STAFF REPORT COMMUNITY DEVELOPMENT DEPARTMENT

SUBJECT: H-2020-0071
Allmon Subdivision

LOCATION: 5885 & 5875 N. Locust Grove Rd.
(Parcel #S0530142200 & #S0530142050;
NE ¼ of Section 30, T.4N., R.1E.)

Final plat consisting of 33 buildable lots and 4 common lots on 9.91 acres of land in the R-8 zoning district.

B. Final Plat (dated: 6/30/20)

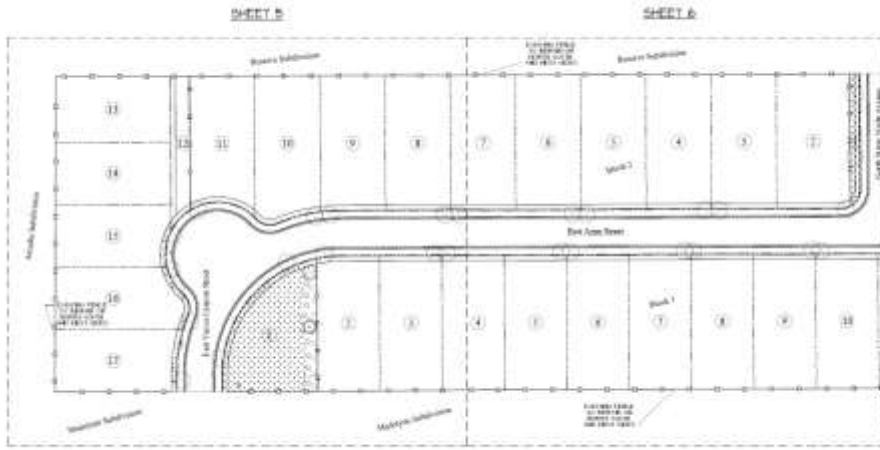
3. Prior to submittal for the City Engineer's signature, have the Certificate of Owners and the accompanying acknowledgement signed and notarized.
4. The final plat prepared by B & A Engineers, Inc., stamped by Joseph D. Canning, dated: 6/30/2020, included in Section V.B shall be revised as follows:

- a. Note #11: "Lots shall not be reduced in size without prior approval from the health authority and the City of Meridian."
 - b. Note #15: "Lots 1, ~~29~~16 and ~~34~~21, Block 1, and Lots 1 and ~~6~~12, Block 2 are common lots . . ."

- c. Note #16: The lot numbers noted as servient to and containing the ACHD storm water drainage system are incorrect; revise accordingly and graphically depict easements on the face of the plat.

- d. Note #17: "Direct lot ~~or~~ access to North Locust Grove Road is prohibited unless specifically approved by ACHD and the City of Meridian."
 - e. Widen Lot 12, Block 2 to a minimum of 25 feet to allow for a 5-foot wide landscaped buffer on the east side of the lot between the common driveway and the fence in accord with UDC 11-6C-3D.5.

A copy of the revised plat shall be submitted for City Engineer signature.

C. Landscape Plan (dated: 07/20/2020) & Site Amenity Details

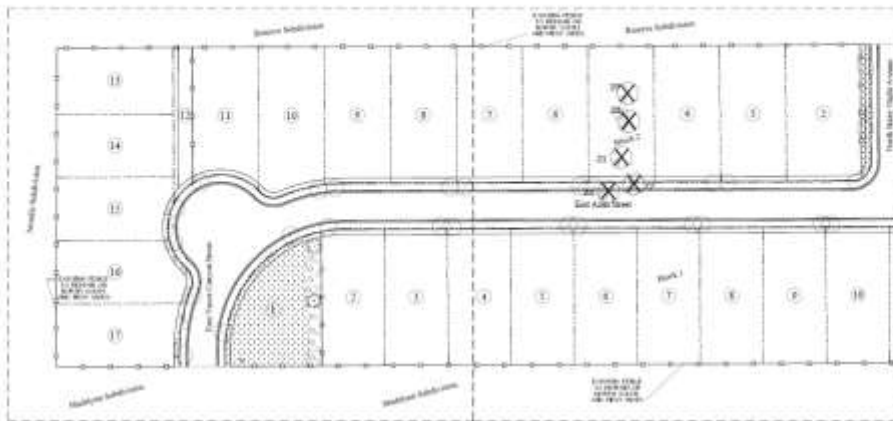
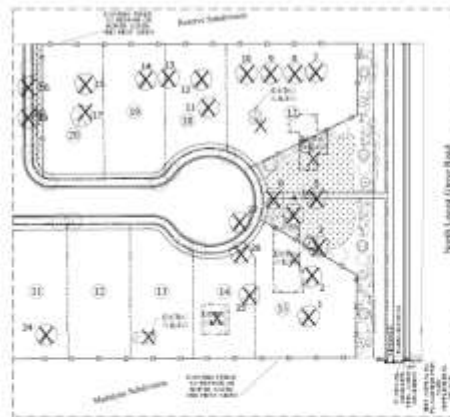
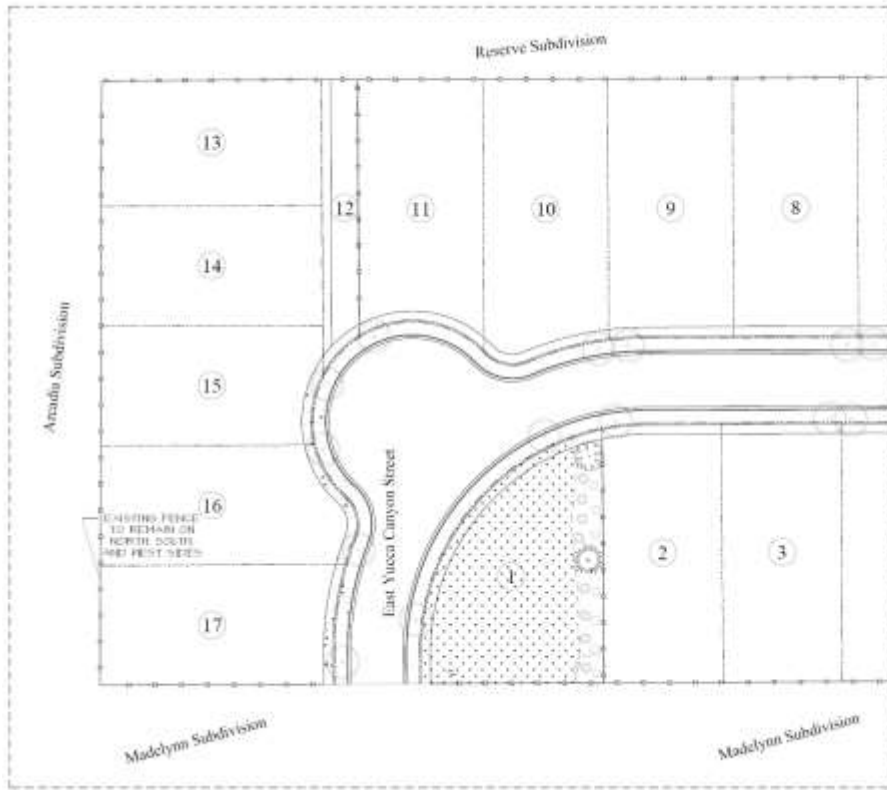
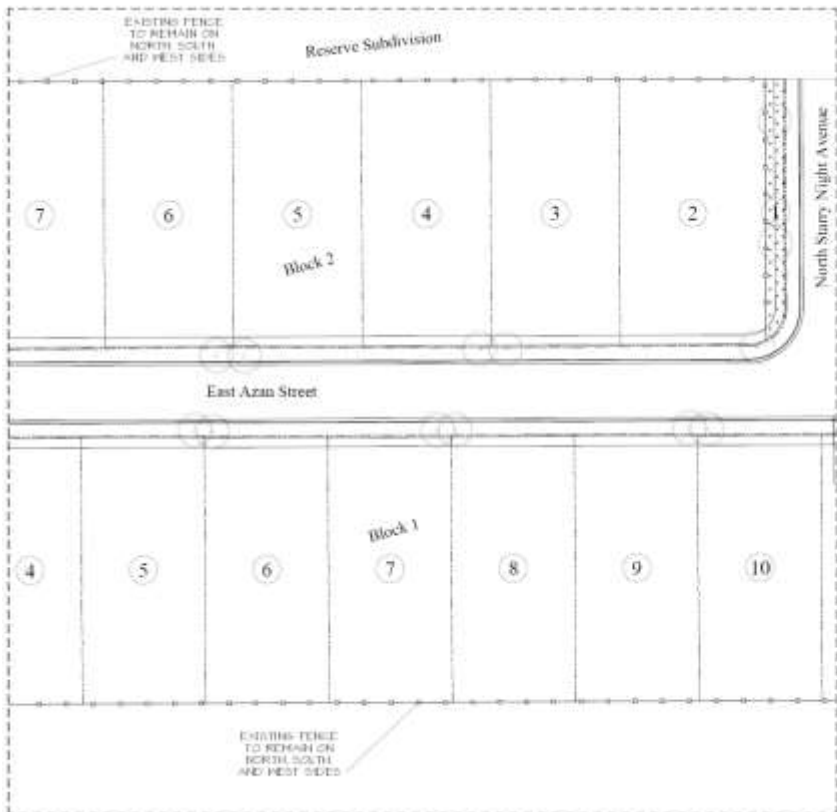
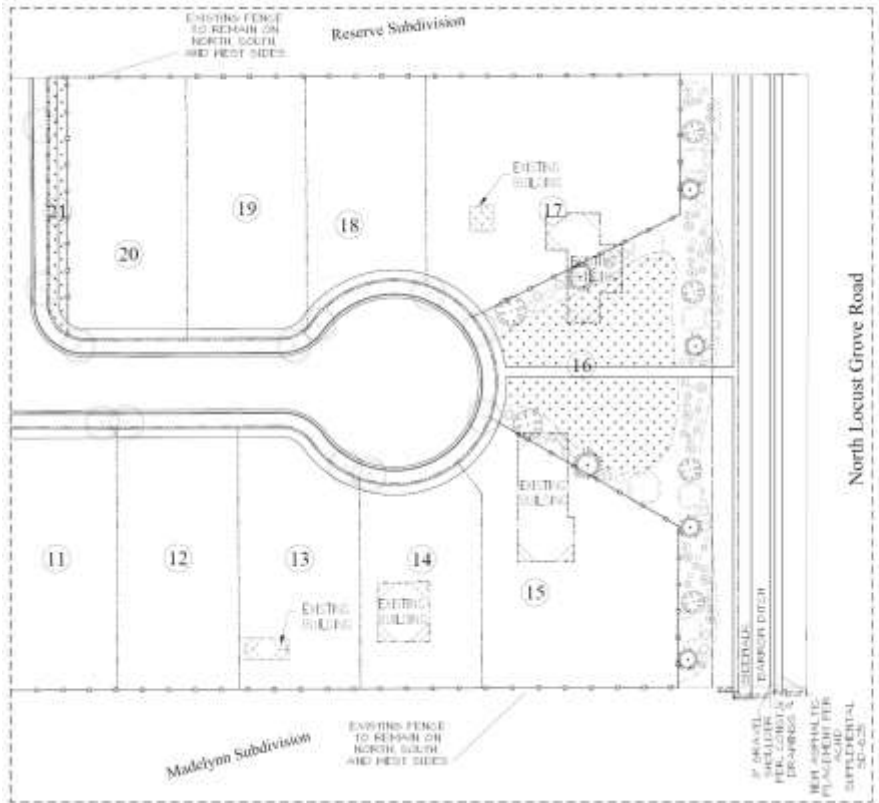
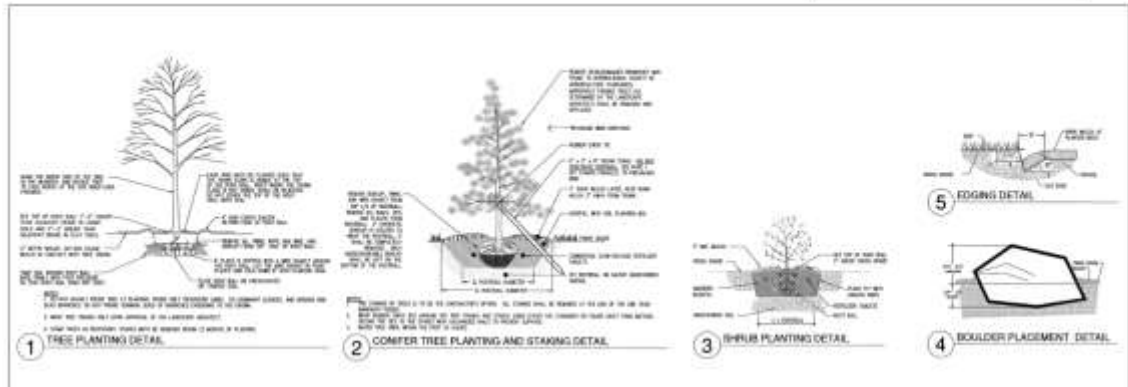
5. The landscape plan prepared by Idaho Precision Landscape., dated 07/20/2020, included in Section V.C, shall be revised as follows:
 - a. Depict a 5-foot wide landscaped buffer on the east side of the common driveway to separate the paved surface of the driveway from the fence in accord with UDC 11-6C-3D.5.

- b. Include the grass symbol in all landscape areas or vegetative groundcover as set forth in UDC 11-3B-5N (i.e. parkways along internal local streets, along Locust Grove Rd., etc.).

- c. If the unimproved street right of way is ten feet (10') or greater from the edge of pavement (along Locust Grove Rd.) to edge of sidewalk or property line, the developer shall maintain a ten foot (10') compacted shoulder meeting the construction standards of the transportation authority and landscape the remainder with lawn or other vegetative ground cover as set forth in UDC 11-3B-7C.5.a. *Landscape improvements within the right-of-way require a license agreement between the property owner and the transportation authority.*

- d. Depict trees along the pathways (micro-path and multi-use pathway) in Lot 16, Block 1 per the standards listed in UDC 11-3B-12C; and include the linear feet of the pathways and the required and proposed number of trees in the Landscape Calculations Table.

- e. Depict the eastern property boundary of the subdivision, the future curb location along N. Locust Grove Rd., and a landscape strip between the curb and detached 10-foot wide pathway/sidewalk.

ALLMON SUBDIVISION LOTS 12-14, BLOCK 1 COMMON DRIVEWAY CONFIGURATION

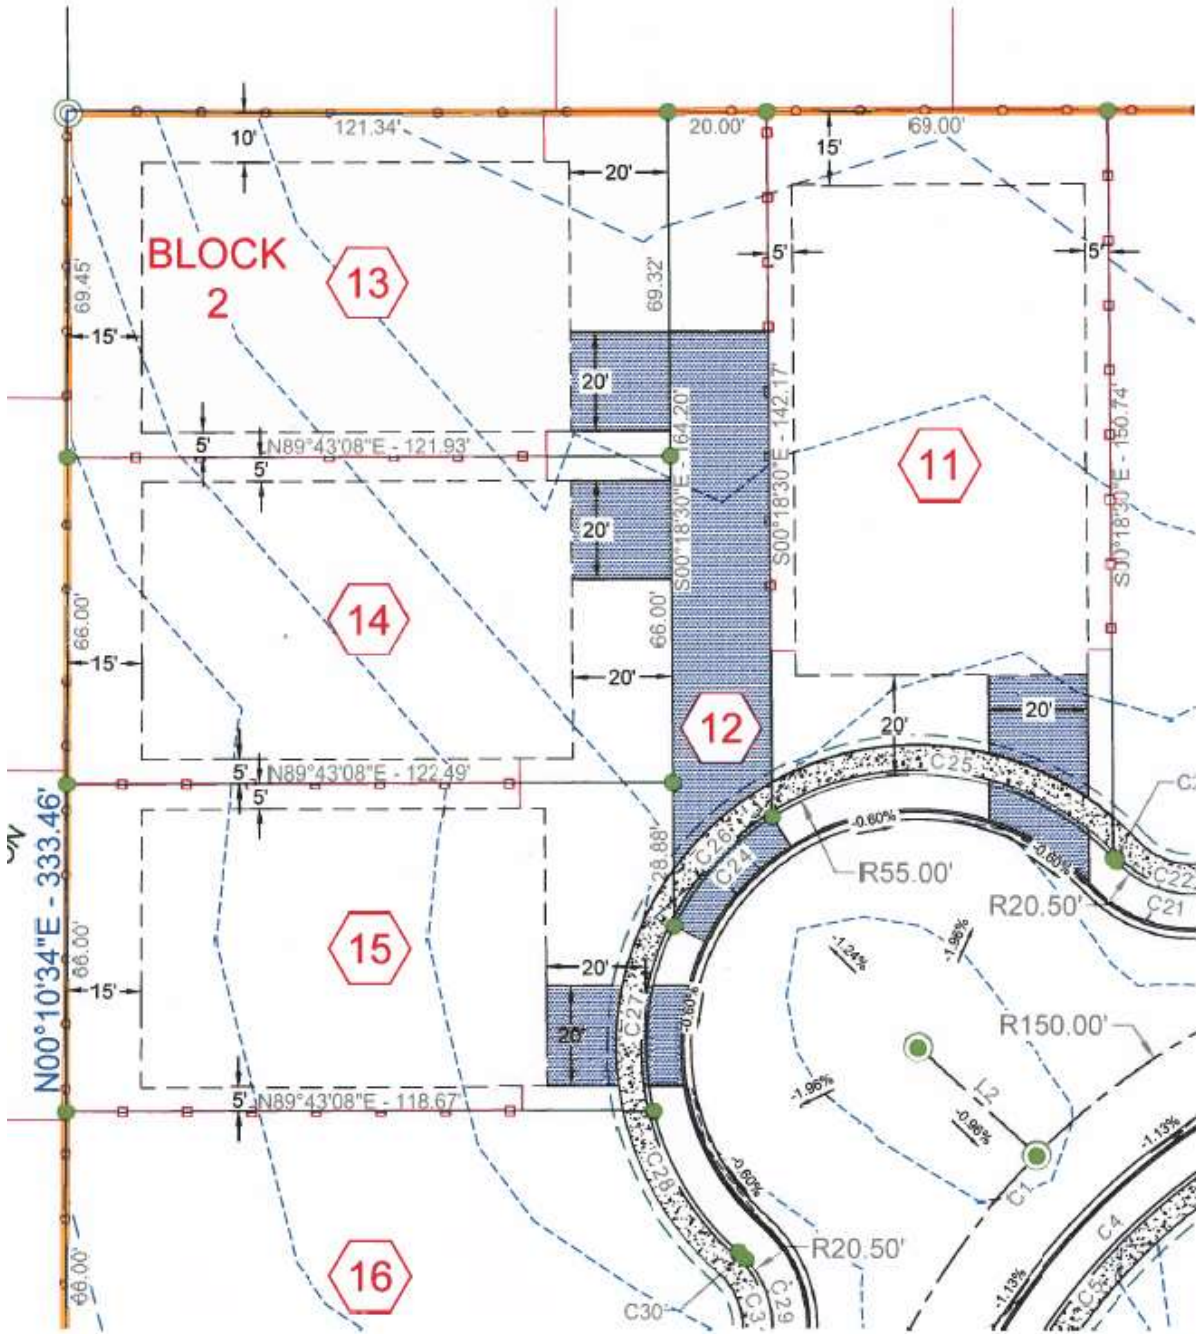
6. A perpetual ingress/egress easement is required to be filed with the Ada County Recorder for the common driveway, which shall include a requirement for maintenance of a paved surface capable of supporting fire vehicles and equipment. A copy of the recorded easement should be submitted to the Planning Division prior to signature on the final plat by the City Engineer; or shall be depicted on the face of the plat.

7. Construction of the common driveway shall comply with the standards listed in UDC 11-6C-3D and with the exhibit in Section V.D.
8. Provide address signage at the entrance to the common driveway at the public street for homes accessed by the common driveway for emergency wayfinding purposes; and sign the common driveway with a “No Parking – Fire Lane” sign as set forth in IFC D103.6 Signs.

13. Future development of Lots 11 and 13-15, Block 2 shall be consistent with the common driveway exhibit in Section V.D.
14. Single-family homes on Lots 14 and 15, Block 2 shall be restricted to 25 feet in height.
